# **Town of Scituate, RI**

**Scituate Animal Shelter Addition**

**RFI responses January 25, 2020**

# SK-001

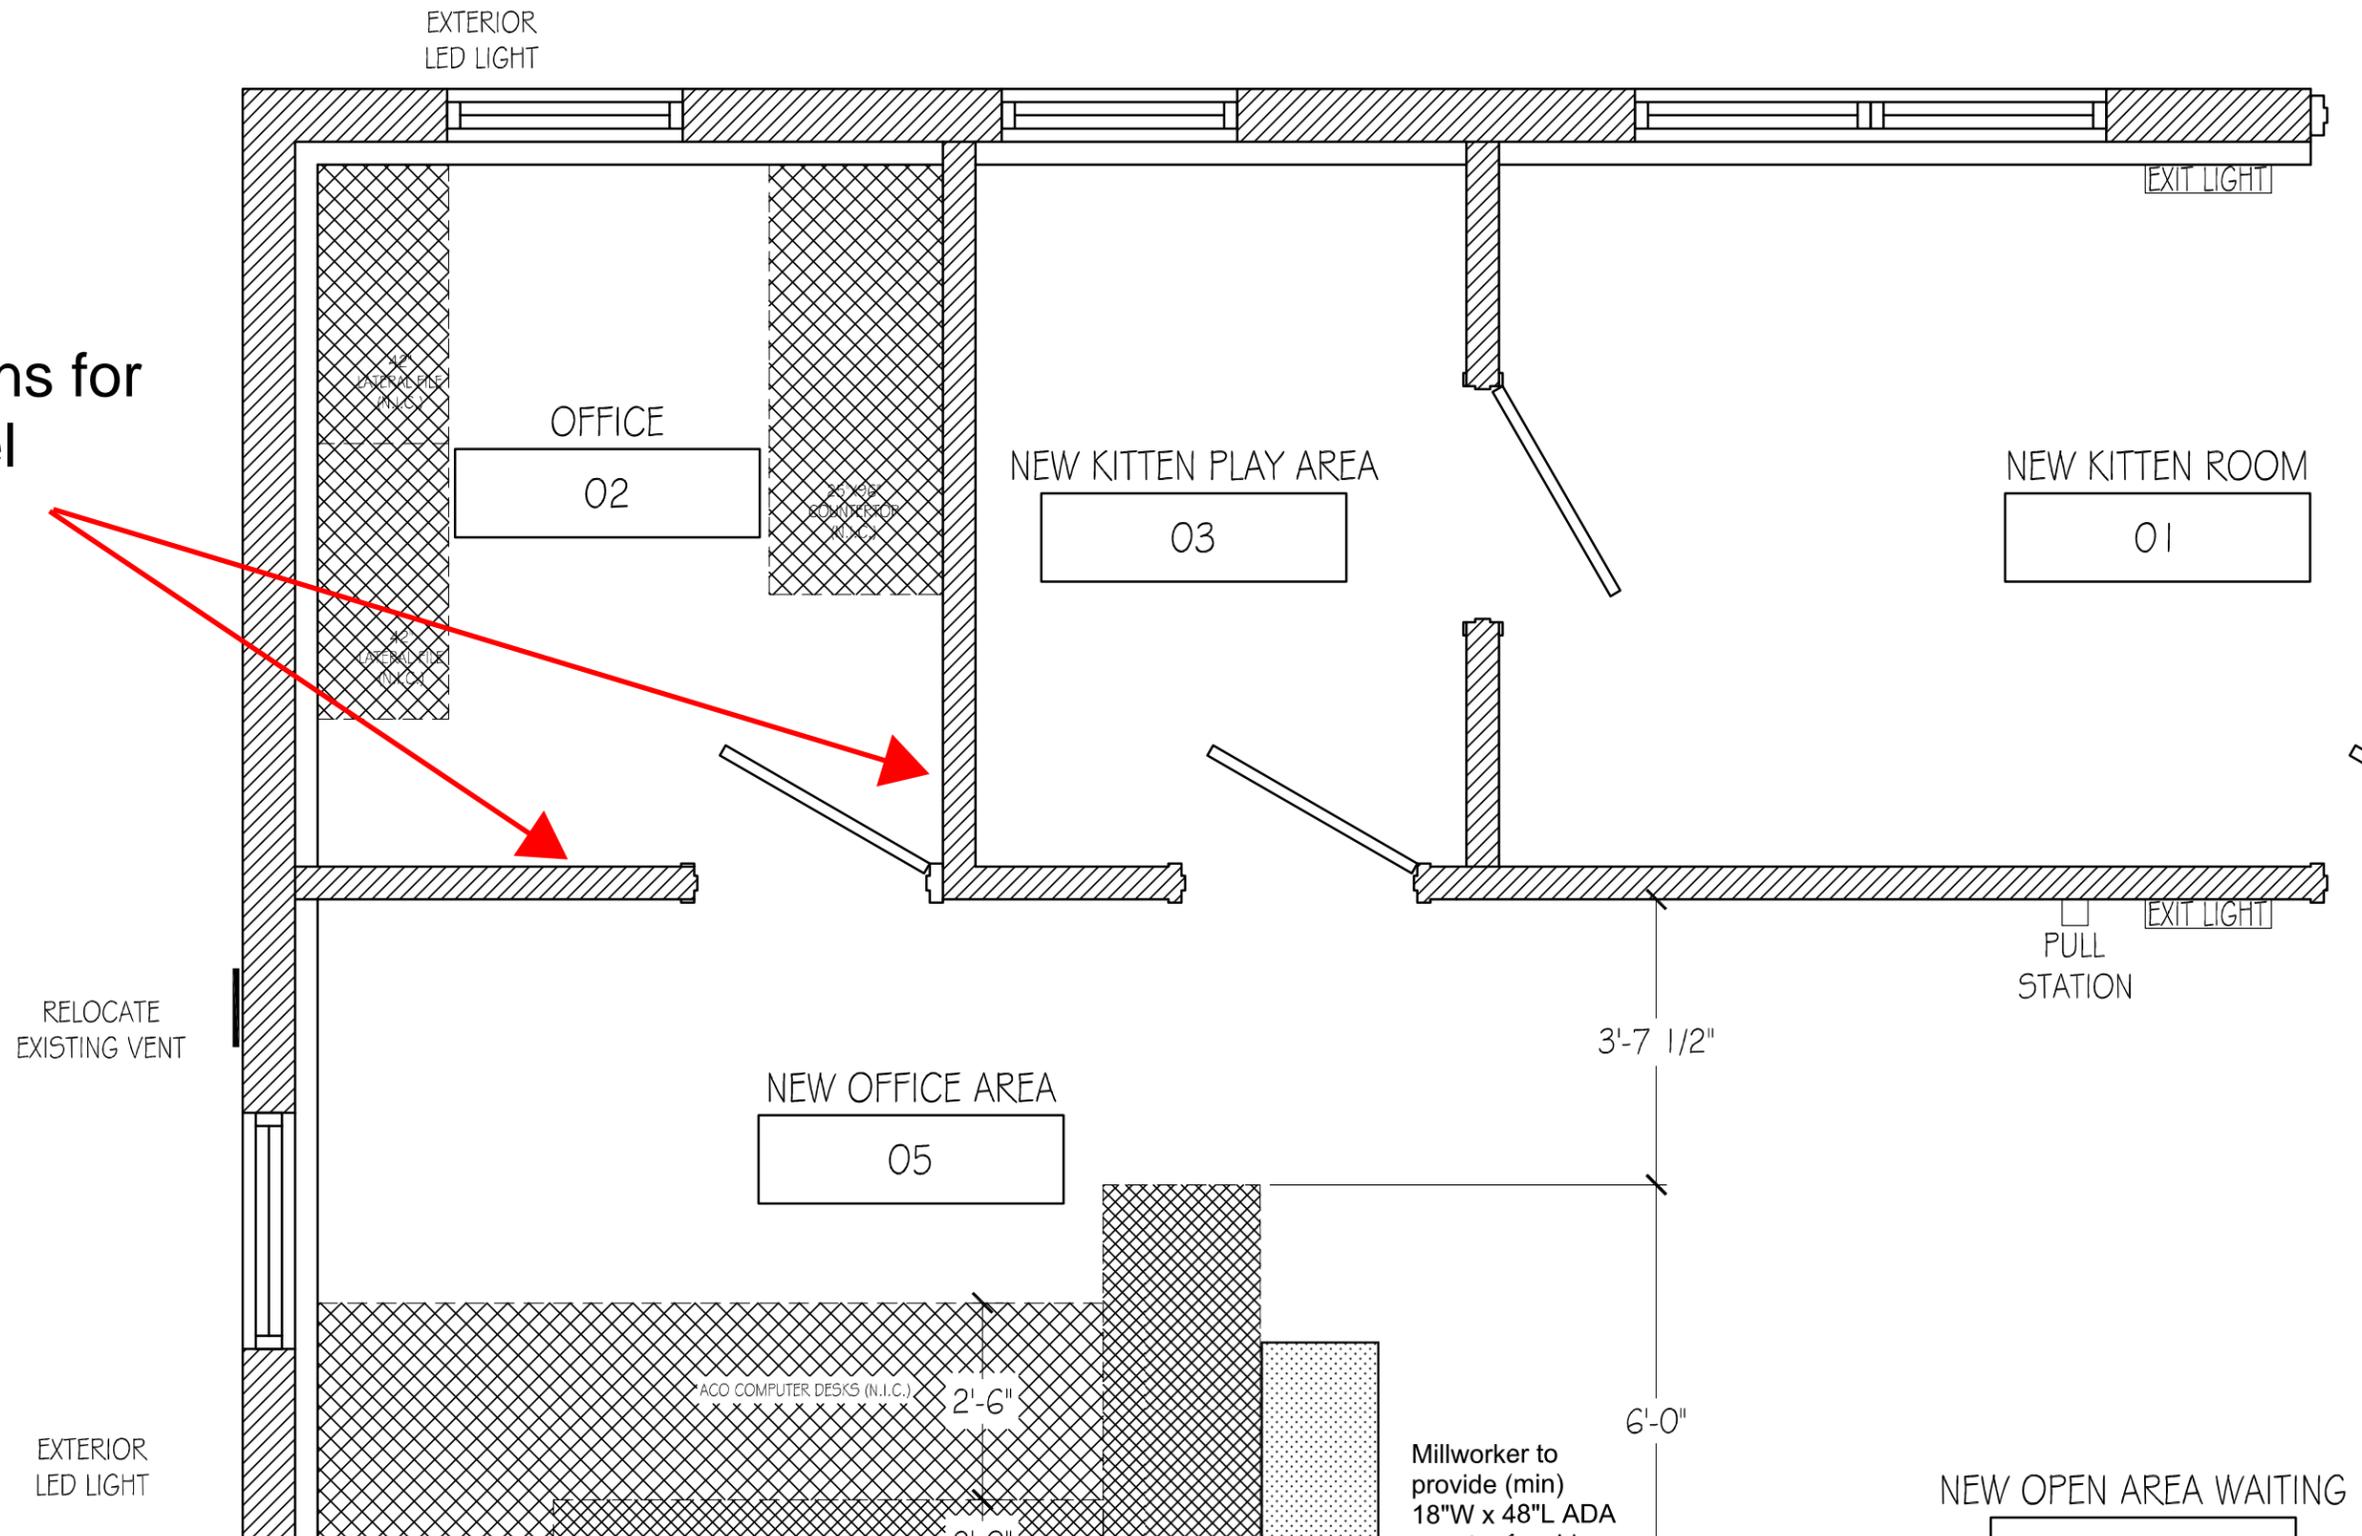
- 9) Where can we place a sub-panel for the new circuits?  
Answer- See SK-001 attached
- 10) Will there be a need for any asbestos or lead abatement?  
Answer- there will be no need for any asbestos or lead abatement.

Acceptable locations for electrical sub panel

# SK-002

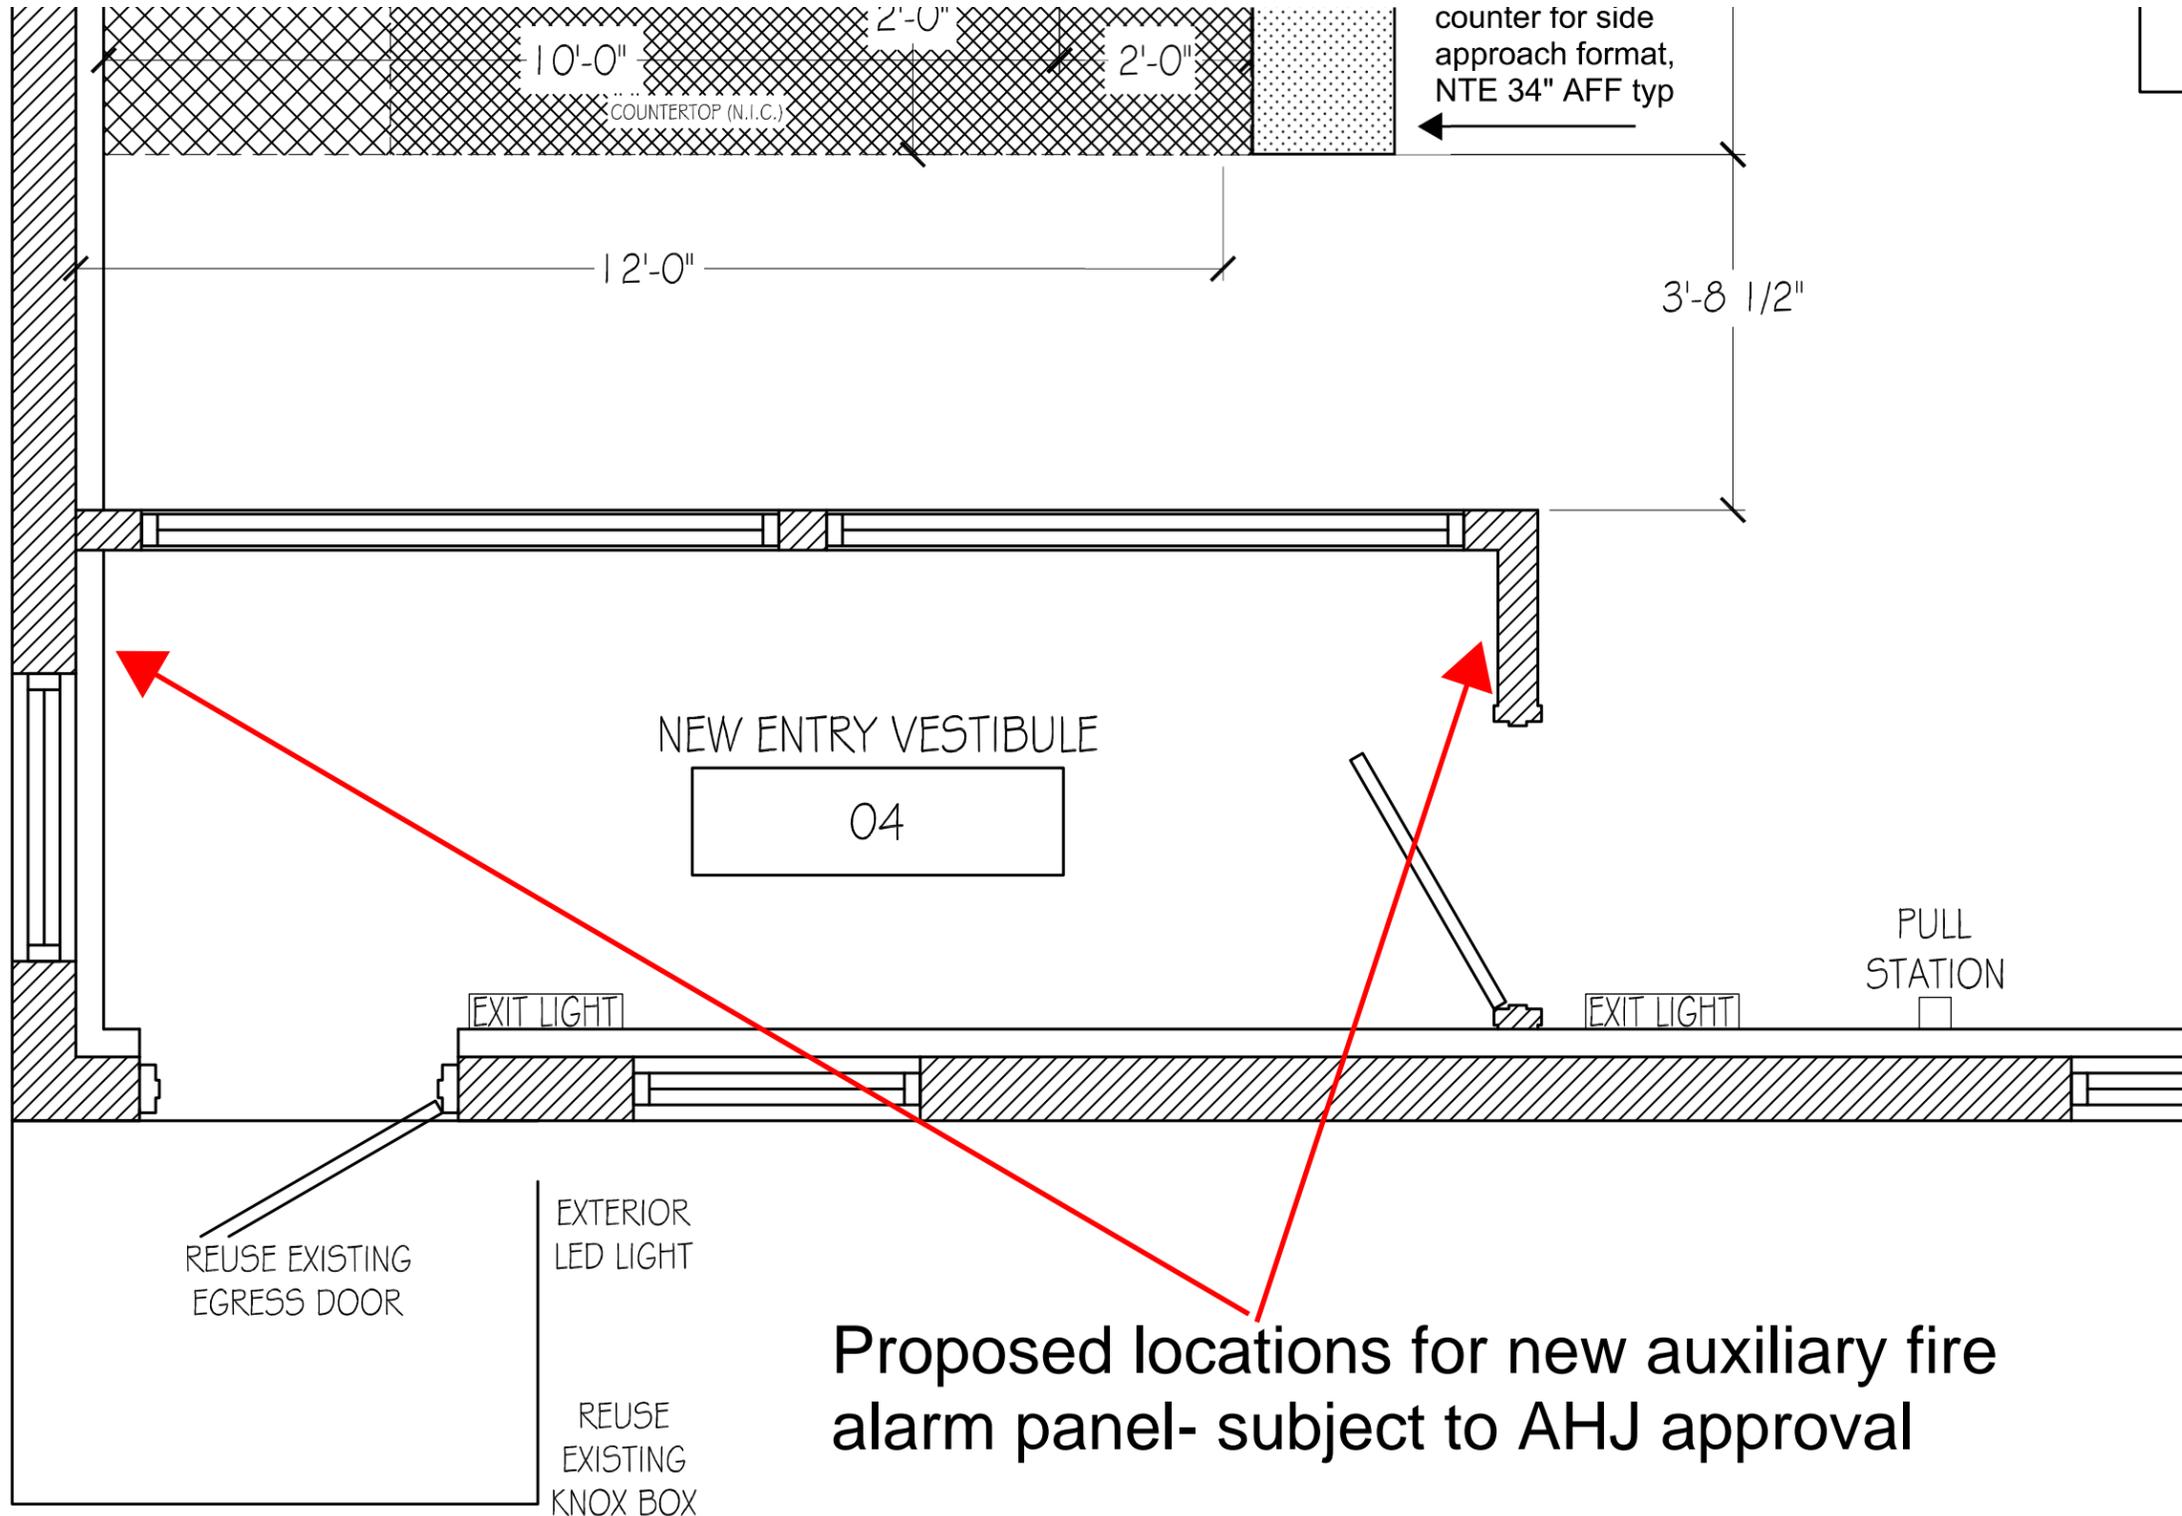
- 11) Where should the auxiliary fire alarm panel be placed?  
Answer- See SK-002 attached
- 12) Can we get a pre-review with the Building Official?  
Answer- the successful bidder will be required to schedule a pre-review with George Dumont, Building Official for the Town of Scituate, RI. Office phone number is 401-647-5901

Proposed locations for new auxiliary fire  
alarm panel- subject to AHJ approval

# SK-003

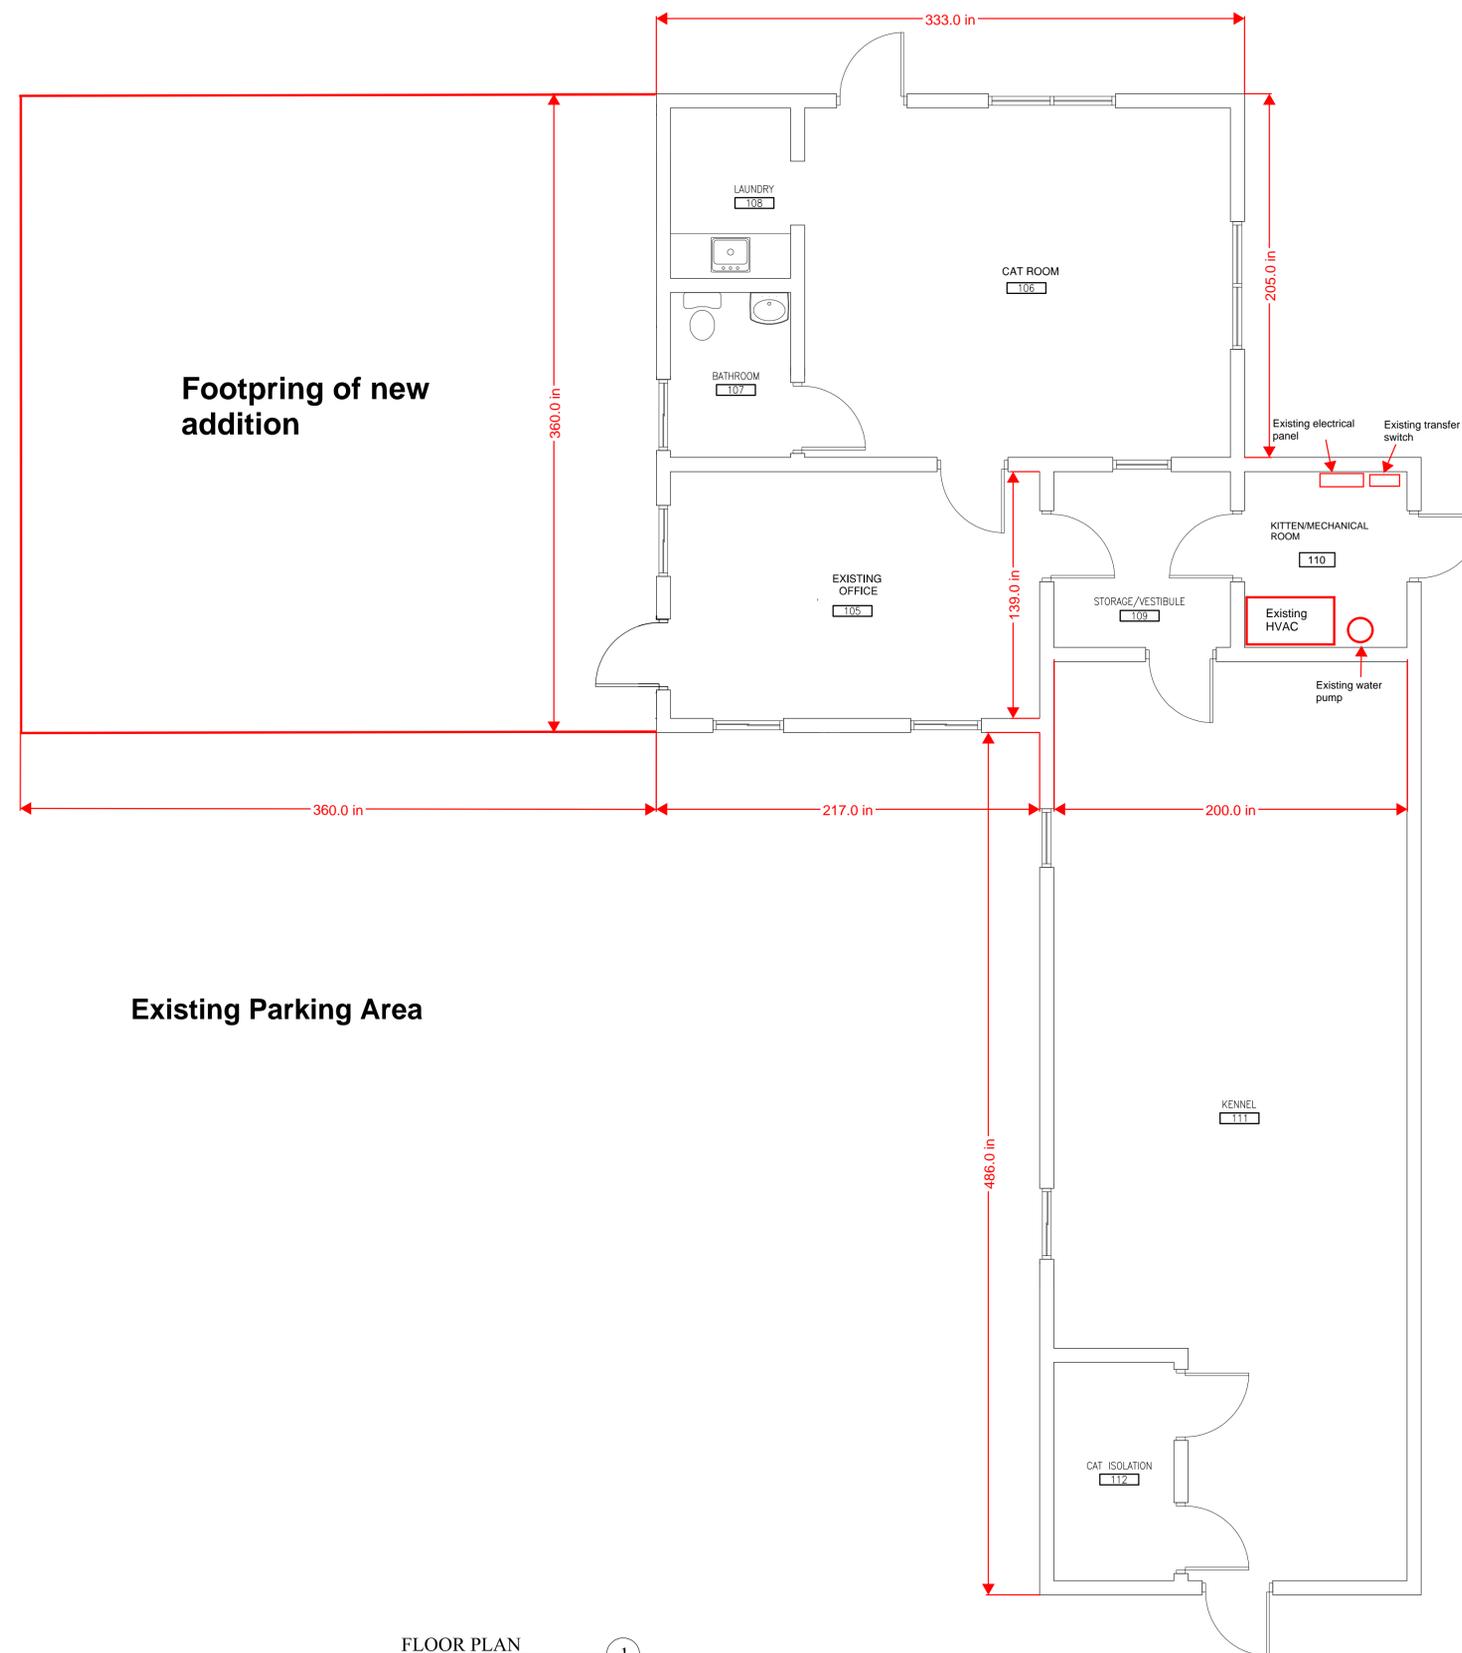
22. Is there a drawing of the existing building we can have?  
Answer- See attached SK-003 for existing building dimensions and footprint of new addition. Note ¼" scale is accurate at Arch D paper size.

**FLOOR PLAN**  
SCALE: 1/4"=1'-0" 1
